Sandleford Park, Newbury

Lee Witts' response to WBC Drainage Statement of Common Ground 10th May 2021

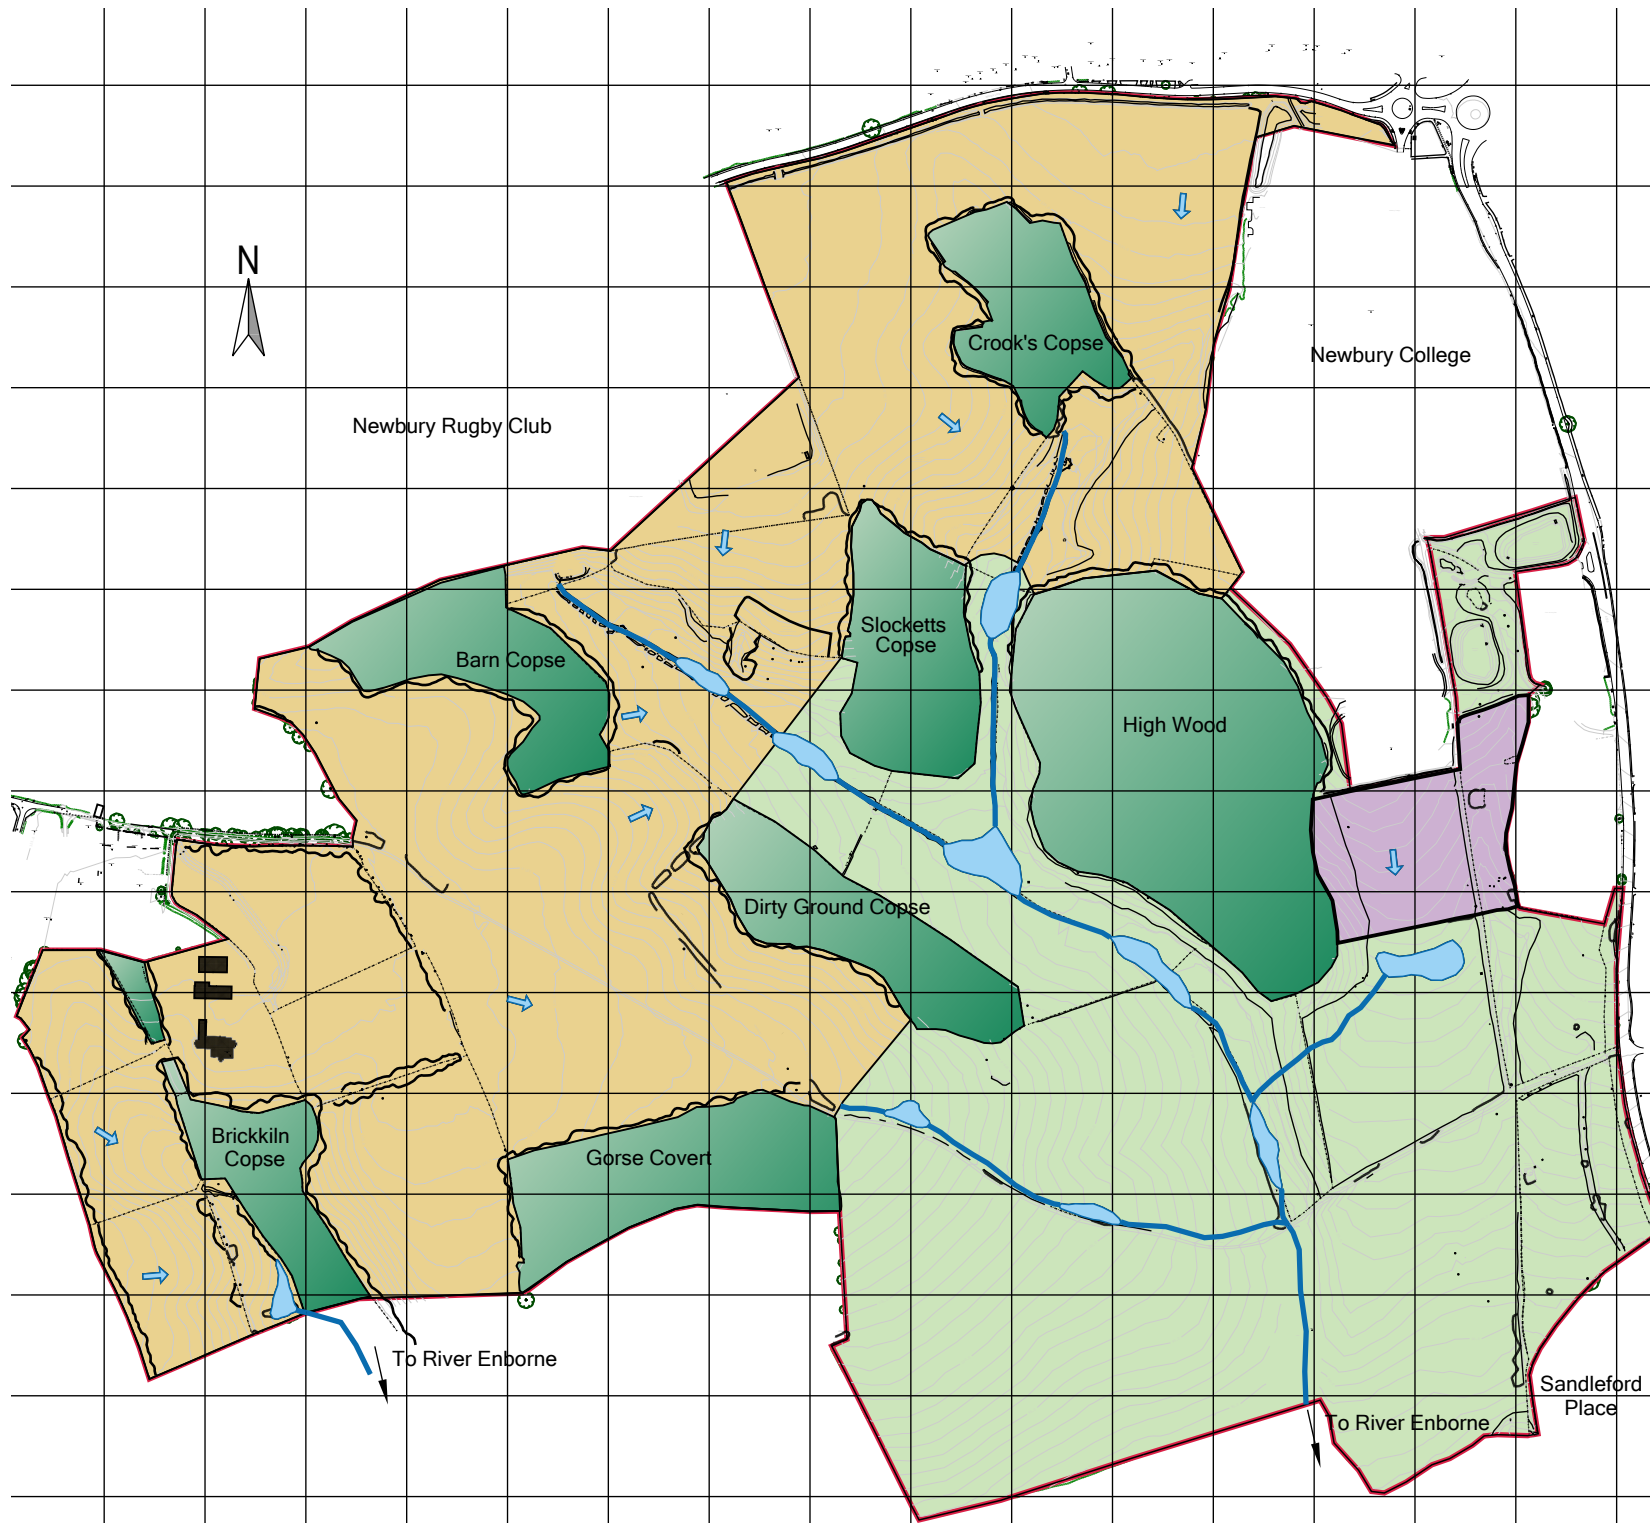
<p><i>2.19 The serpentine Crook's Copse Link shown on drawing VD17562-SK021 in Appx. 4 of the Section 78 Appeal : SoC, crossing the valley between Crook's and Highwood/Slockett's will affect adversely hydrology in this valley; the link road will effectively block the natural flow of water through the upper ground layer down through this valley permanently causing detriment to the marshy or boggy areas to the south of this crossing;</i></p>	<p>It is correct for Mr Bowden to state that the natural flow of water will be altered. The circa 15m long culvert beneath the Link is the proposed conveyance system for water once the Link is in place. However, the Link is not currently fixed in terms of arrangement and is subject to detailed design. The proposed culvert, along with all other details associated with the Link, will be tested and agreed further through reserved matters.</p> <p>However, the principal of a culvert within or near to Crook's Copse is nothing new. Mr West's Proof (CD10.13) under para 4.2.10 when discussing modular river surveys states: "For the Crooks Copse link, (which will introduce a culvert) it is because the watercourse is already culverted in sections, with a lengthy section where it runs entirely below ground."</p> <p>Mr West's on site surveys shows that there are existing sections of watercourse that are culverted on the site. Two examples of this are provided here:</p> <p>Approximately 130m south of the new Link road, in between High Wood and Slockett's Copse, there is a section of existing watercourse which is culverted for approximately 60m in length.</p>

<p>The watercourse between Monks Lane and the northern edge of Crook's Copse is entirely culverted at approximately 95m in length.</p> <p>Therefore, the introduction of a new culverted section of just 15m in length is not seen as detrimental when compared to the existing conditions.</p>
<p><i>2.20 The Council's position is that construction of the Valley Crossing will cause significant harm to the hydrology and ecology of this valley and surrounding area during the work. There will be some residual harm upon completion when in use;</i></p>	<p>Whilst this comment is acknowledged, the evidence given by Mr Goddard to the Inspector within the 6th May Inquiry sessions was that the Valley Crossing is "necessary".</p> <p>Furthermore, referring once again to Mr West's Proof (CD10.13), para 4.2.10: "As part of the updated Biodiversity Net Gain Assessment (Appendix B) a Modular River Survey has been conducted on both sections of watercourse where crossings are proposed. This assessment concludes that there will be no impact on the condition of the watercourses as a result of the proposed development. For the central valley crossing, this is principally because the width of the proposed bridge structure is below the threshold for shading impacts to be significant (it is less than 25m wide)."</p> <p>Even so, it is unreasonable to declare a position of "significant harm" when the detailed design and construction management of the Valley Crossing has not yet been carried out.</p>
